OFFICE OF THE CHIEF EXECUTIVE OFFICER

2 December 2022

**Subject: Woodlawn Advanced Energy Recovery Centre (SSD 21184278)
Submission on the Environmental Impact Statement**

VEOLIA | neffleton | Woodlawn Advanced Energy Recovery Centre | Design Report | June 2022

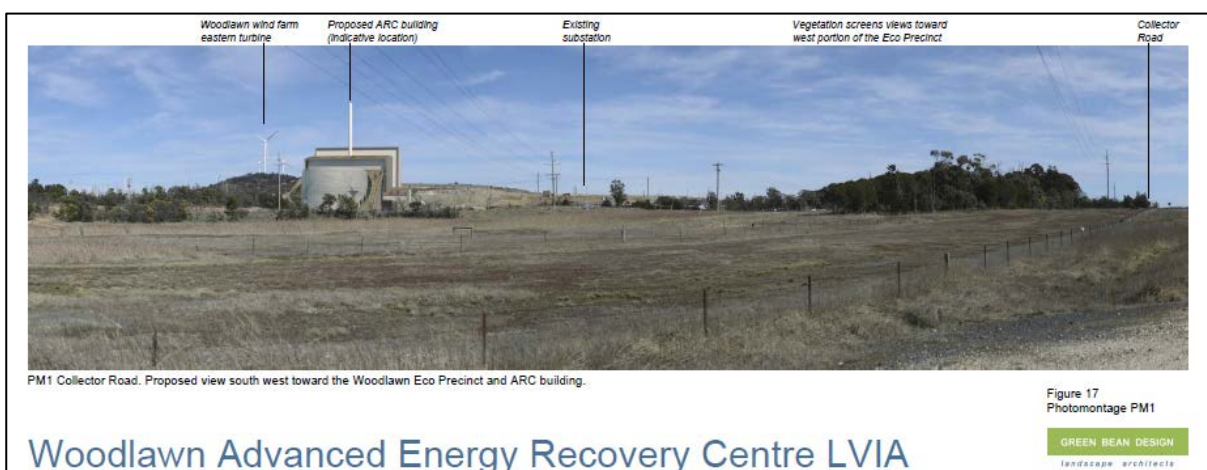
The ARC building is 54m high (see above). The emission stack is 85m high. By comparison the existing wind turbines at Woodlawn are 80m high to the hub (centre of the blades) and 124m at the highest point of the blades (noting that the base of the turbines is also at a higher elevation). The encapsulation cell is 30m high.

Planting will not be able to completely screen the development given the scale of the emissions stack and buildings, however it will reduce its visual impact. The area planted will have to be substantial to have a significant screening effect. When mature (after 50-100 years) certain Eucalypts found locally will reach a height of 25-30 metres, however this would only be achieved well beyond the anticipated life of the plant.

ACTION: *The plant species used for screening purposes should be selected from the Native Plant community found in the vicinity of the site.*

A mixture of trees, shrubs and groundcovers should be used. This will provide an additional environmental benefit as well as screening the development.

ACTION: *A long term planting maintenance schedule should be provided and adhered to. The maintenance plan should contain a schedule of works that includes an annual timeline for weed management, plant replacement where needed, monitoring for pests and diseases, and watering etc.*

PM4 Weereewa Lookout – located on the western shore of Lake George

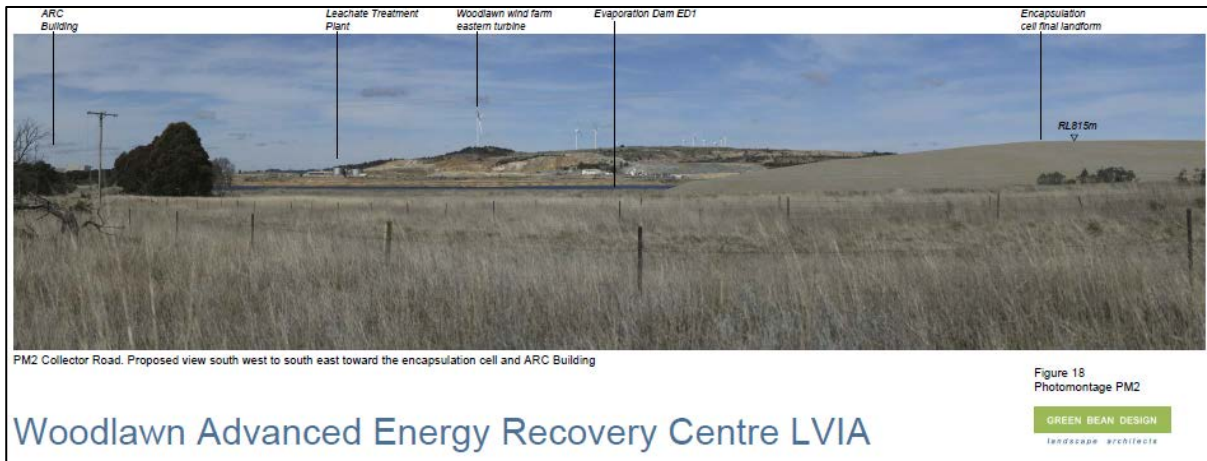
The most relevant photomontages from Appendix BB Landscape and Visual Impact Assessment are reproduced below. The most significant visual impact can be seen in the first image PM1 Collector Road. Screen planting in this area will reduce the visual impact. The same goes for the second image PM2 Collector Road, but the visual impact is less, given the increased distance from the development.

Figure 3 - Chart 1 page 10 of Appendix E

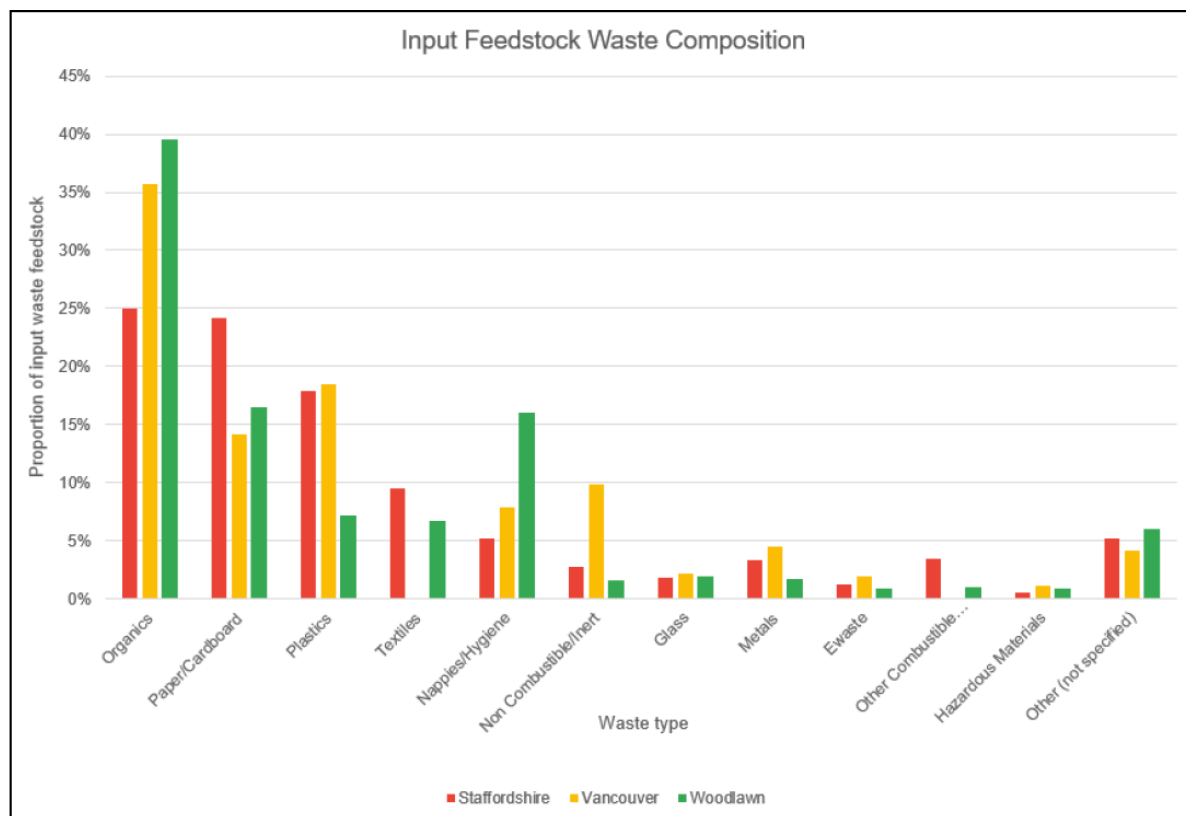
Section 3.2 describes the feedstock as being broadly consistent with organics, paper/cardboard and plastics which make up the bulk of the feedstock. The report determines the bulk to be greater than 66%. Unless 66% is a given value somewhere the bulk of the feedstock would be those items that have the highest value in any group. Using Chart 1, the bulk of the feedstock material (say any group 10%) for Woodlawn is derived from organics, paper/cardboard, plastics, nappies/hygiene. Whereas Vancouver, it would be organics, plastic, and nappies/hygiene.

- *Organics comprise a higher proportion of the feedstock for Woodlawn than the reference plants, by up to 15% -*
This doesn't appear to be correct because it is just looking at the number on the graph. The reality is Woodlawn will process about 60% more organics than Staffordshire (UK). 15% sounds better than 60%
- *Paper/cardboard content varies by up to 10% between plants, with Woodlawn in the mid-range of the dataset.*
Again, this is just looking at the difference between the high and low numbers, plus Woodlawn is not in the mid-range. The values are Staffordshire 24.5%, Vancouver 14.2%, and Woodlawn 16.5%

ACTION: *Appendix E makes assumptions on the likely waste outputs based on the comparison with other EfW plants, however, data used to justify the argument that the “input waste stream will be generally the same” in fact demonstrates that the reference data is dissimilar. Consequently, a different waste input stream would result in a different waste output. Therefore, Appendix E cannot be used to support the likely waste outputs because it is modelling different data. A reevaluation of the waste input model is required.*
